153-157 Walker Street Response to DPHI and NS Council Comments

1. Response to DPHI Comments

Response to DPHI Comments

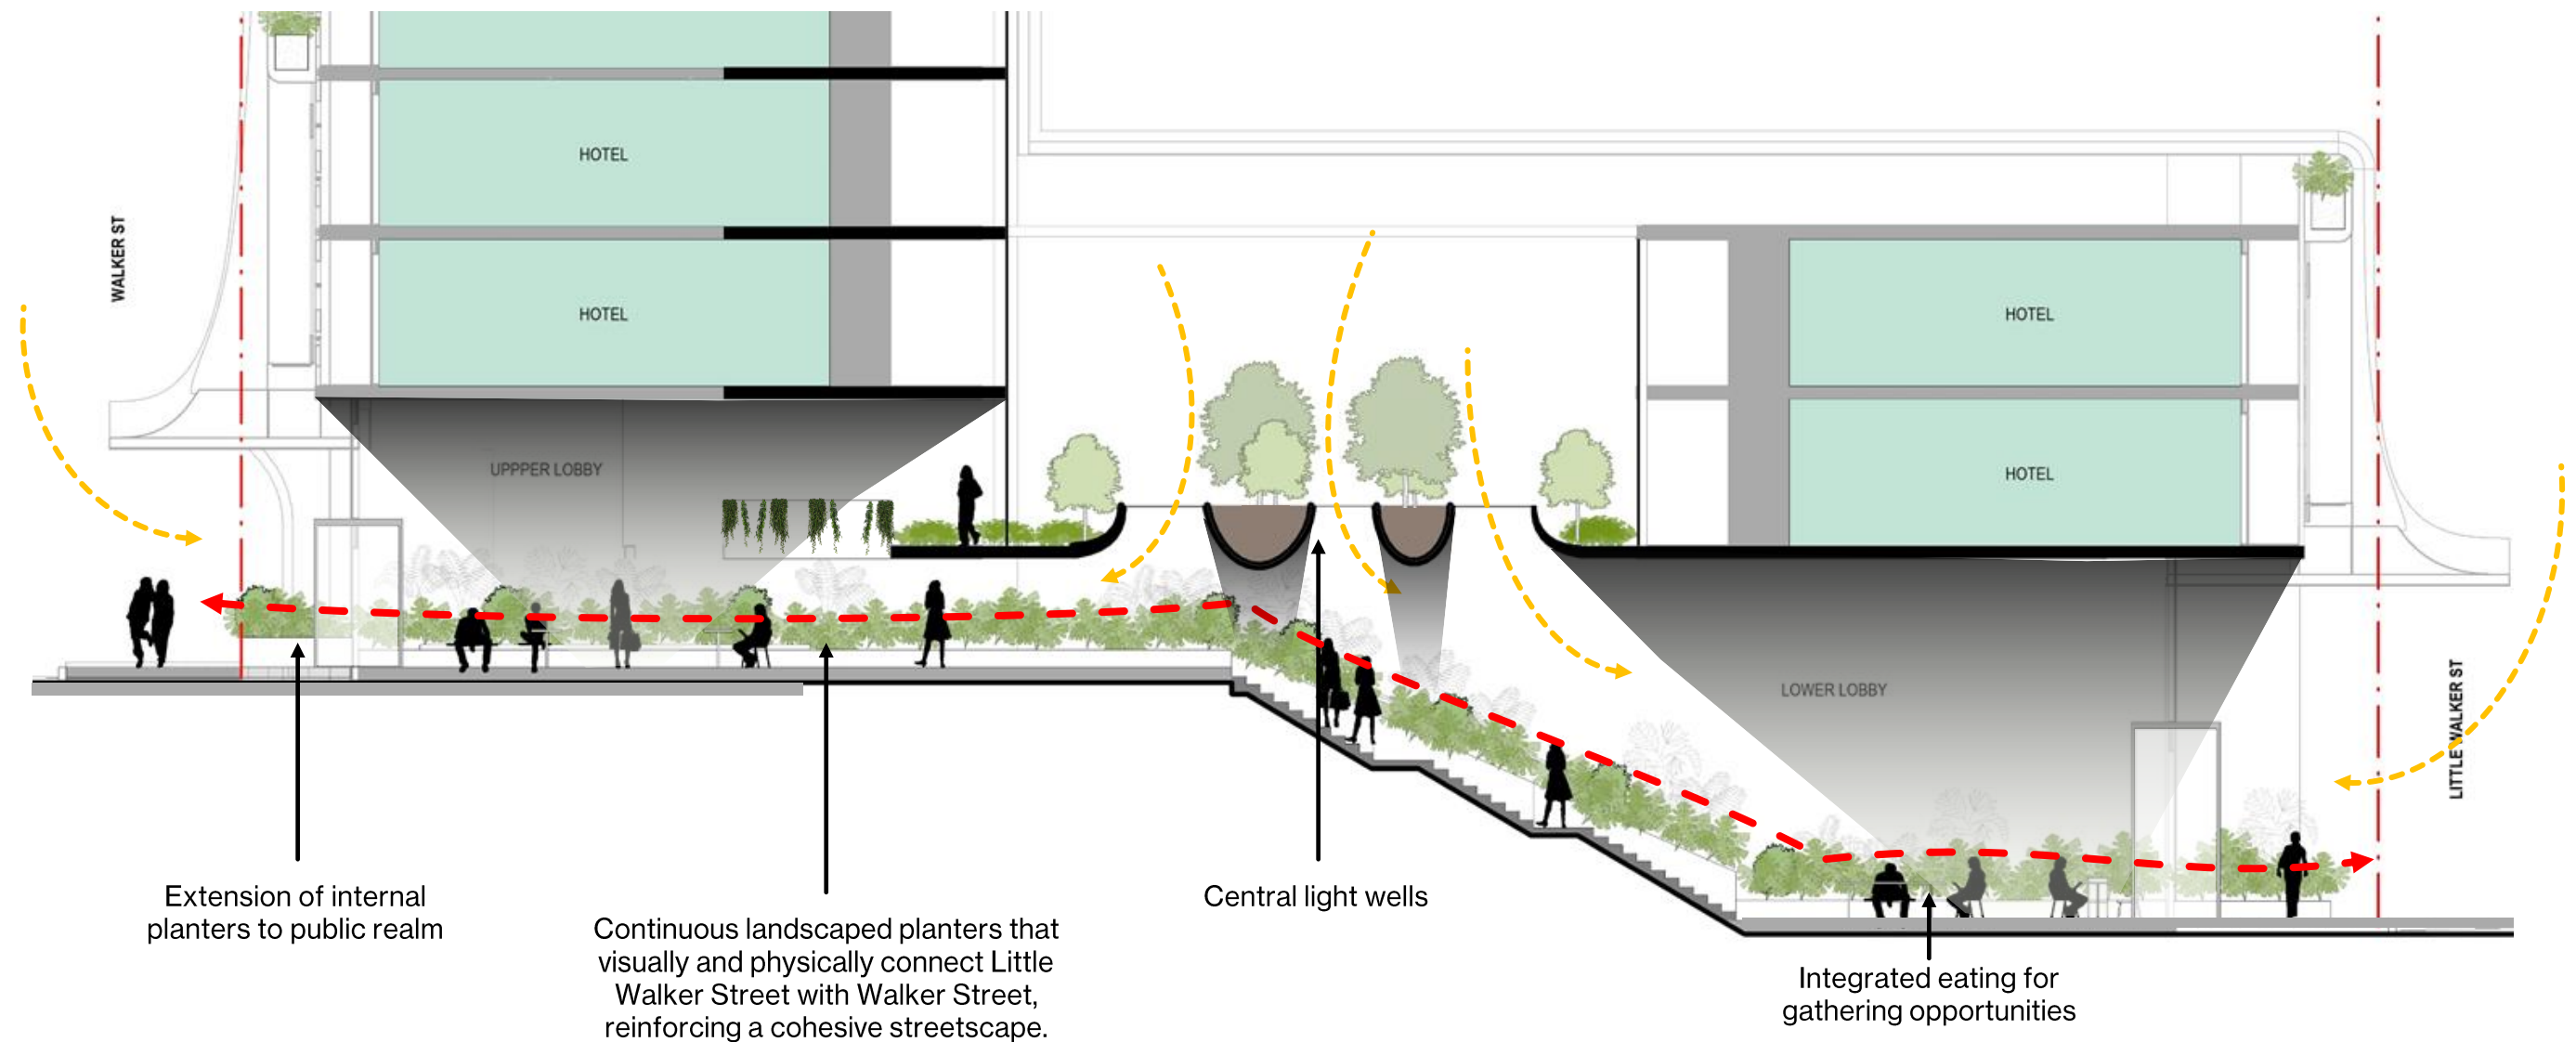
D. Arcade link design lacks clear wayfinding and activation.

The through-site link has been designed with architectural cues that enhance wayfinding and connectivity.

1. Continuous landscaped planters extend from the interior out onto Walker Street and Little Walker Street, visually and physically connecting the edges and softening the transition between building and public realm. Their curved form incorporates opportunities for informal seating and passive occupation, supporting pedestrian comfort and activation.

2. A central light well introduces natural daylight deep into the passage, improving visibility from both entries and encouraging movement through the arcade.

3. The link is internal and necessarily enclosed for security and operational reasons, therefore cannot function identically to a fully open through-site connection. However, the architectural arrangement provides strong sightlines, spatial cues, and clear visual permeability, with signage to be developed in upcoming stages to further enhance wayfinding and activation as required.

Level 08-14

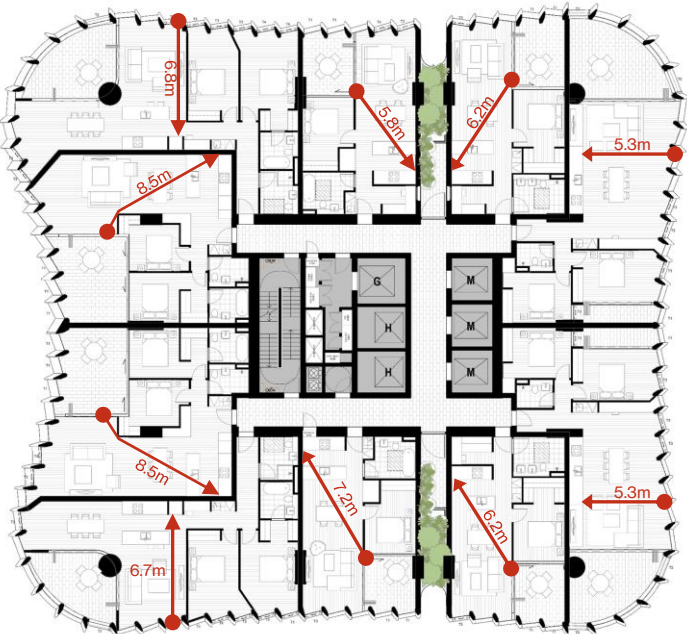
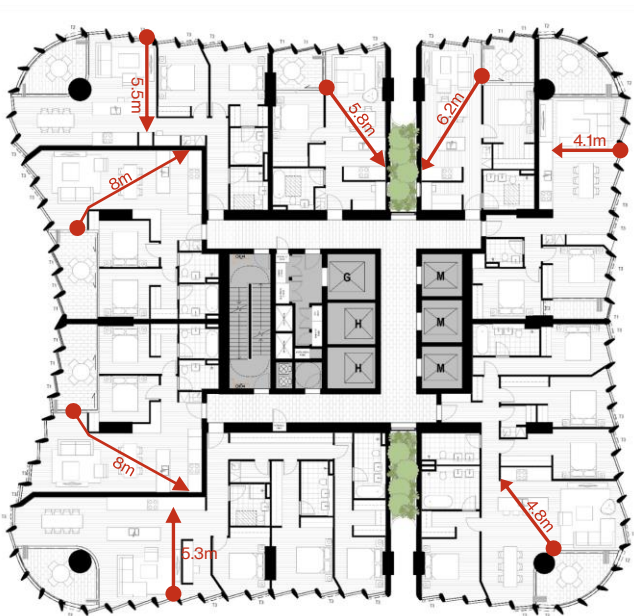
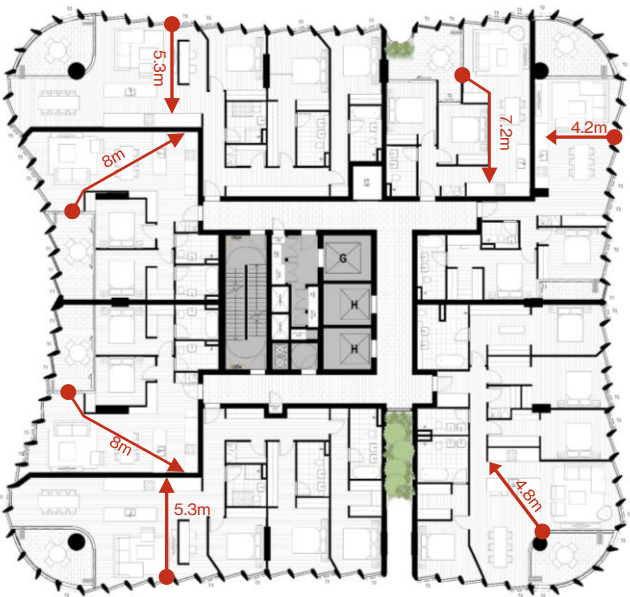
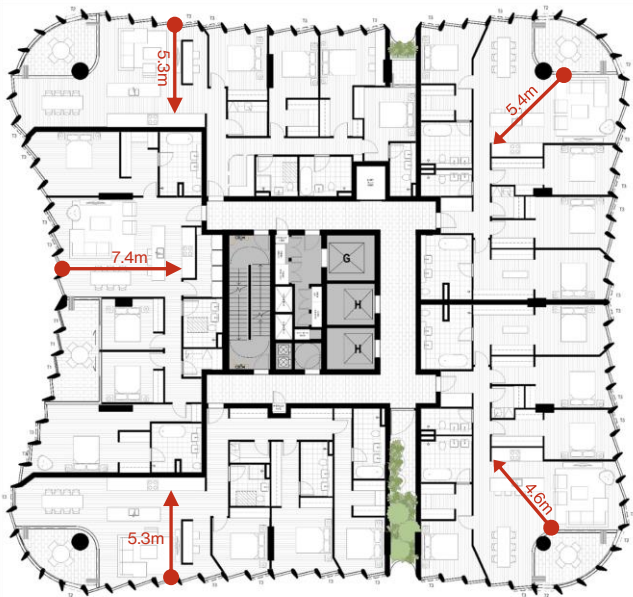
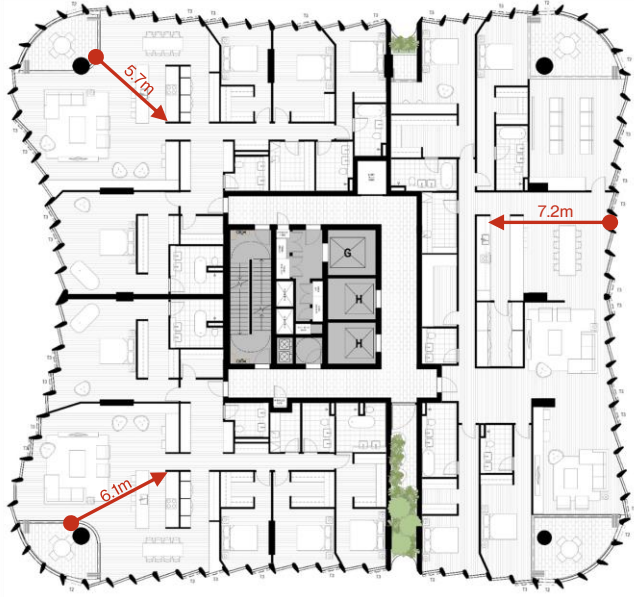
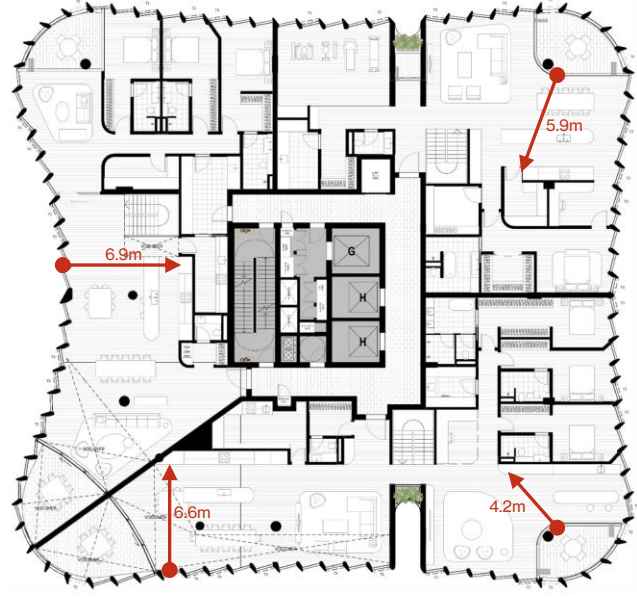
B. Room Depths: Habitable rooms exceed 6.75m depth limit, reducing daylight and ventilation.

The following plans demonstrate that all typical floors in the tower comply with habitable room depth requirements as specified in ADG.

All units have been designed as an open layout enabling the application of the ADG’s 8 meter maximum depth allowance, and no instances in the building exceed this 8 meter limit. The layouts maintain good access to daylight and natural ventilation, achieving the performance intent of Objective 4D-2.
